# STAFF RECOMMENDATION

NCPC File No. 6979

## DISTRICT OF COLUMBIA WAR MEMORIAL RESTORATION AND REHABILITATION

March 25, 2010

**Proposed Paving Pattern**

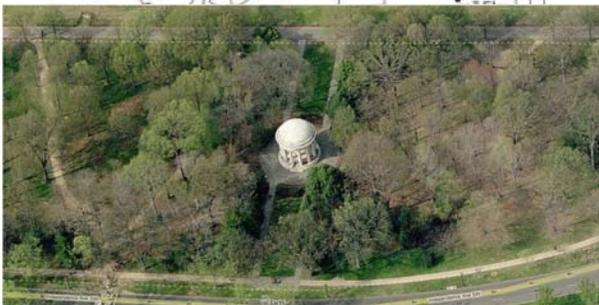
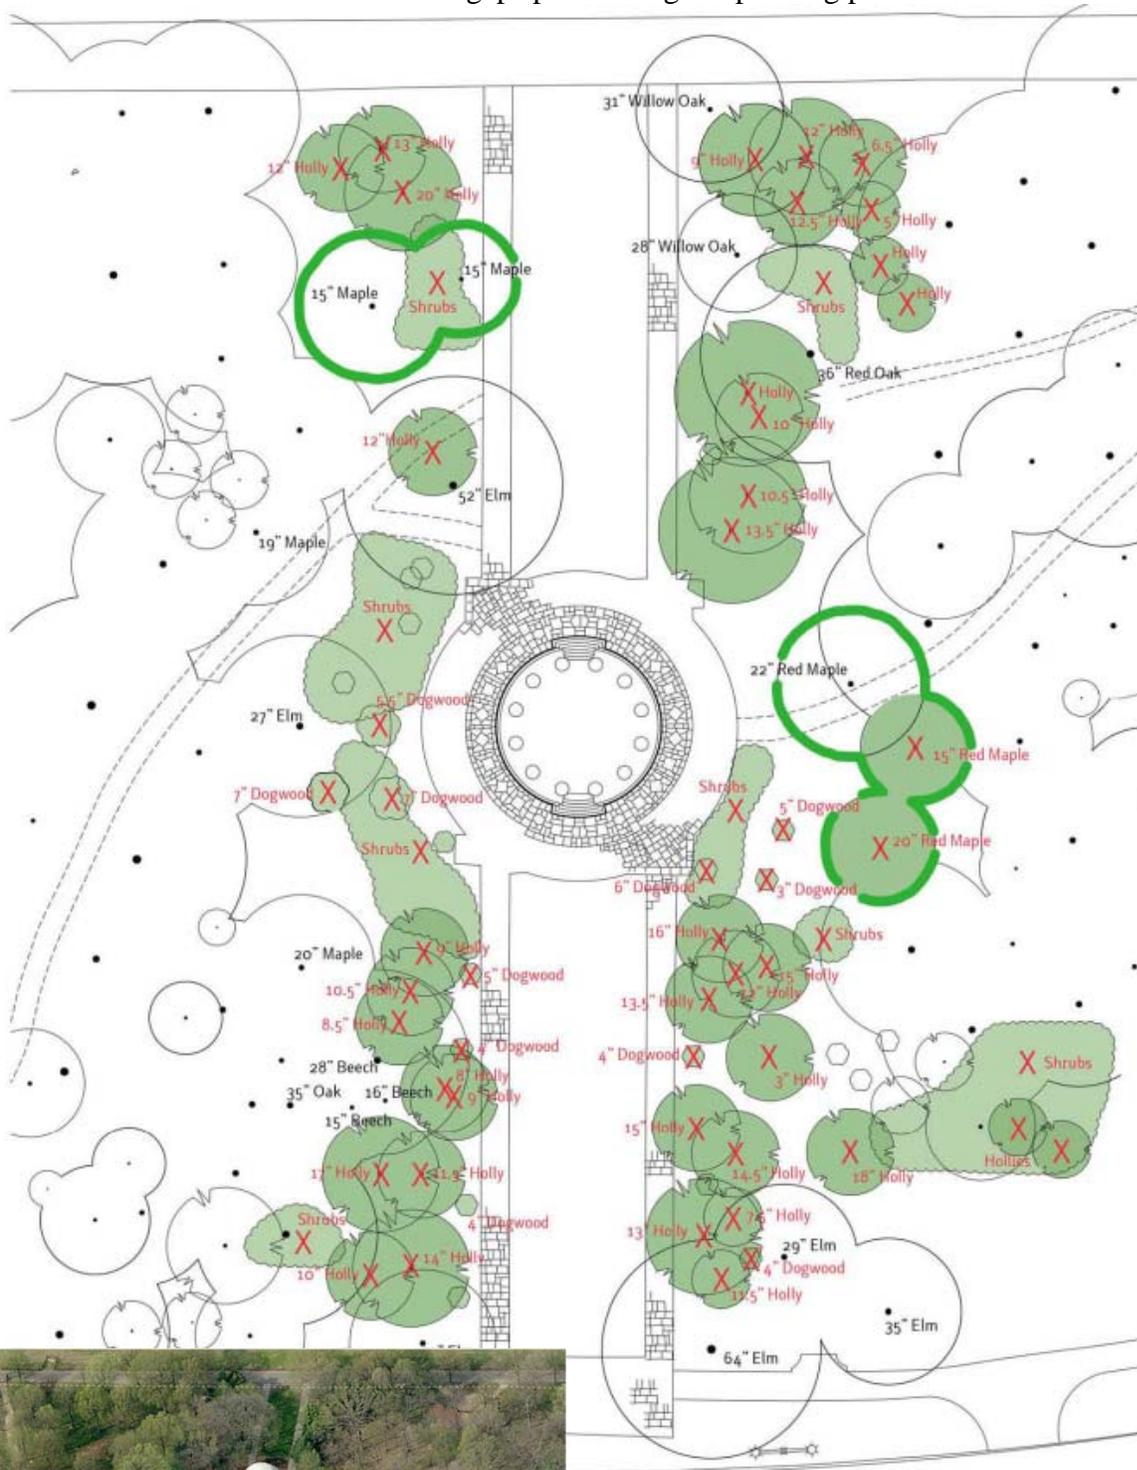
Staff has evaluated the proposed paving pattern and praises NPS for restoring the historic bluestone eight foot ring at the base of the memorial. In addition to the historic ring at the base of the Memorial, NPS will also replace the paving that was added to the eight foot ring in 1939. While the additional bluestone ring around the base of the memorial does not follow the original design of the memorial, the additional paving was added in order to handle increased visitation and use not taken into account with the original design. Staff is supportive of NPS using the shape of the 1939 paving as it will handle anticipated increases in visitation expected at the site once the Martin Luther King Jr. Memorial is opened. Staff praises NPS for undertaking the memorial restoration and rehabilitation of the grounds prior to the increased visitation.
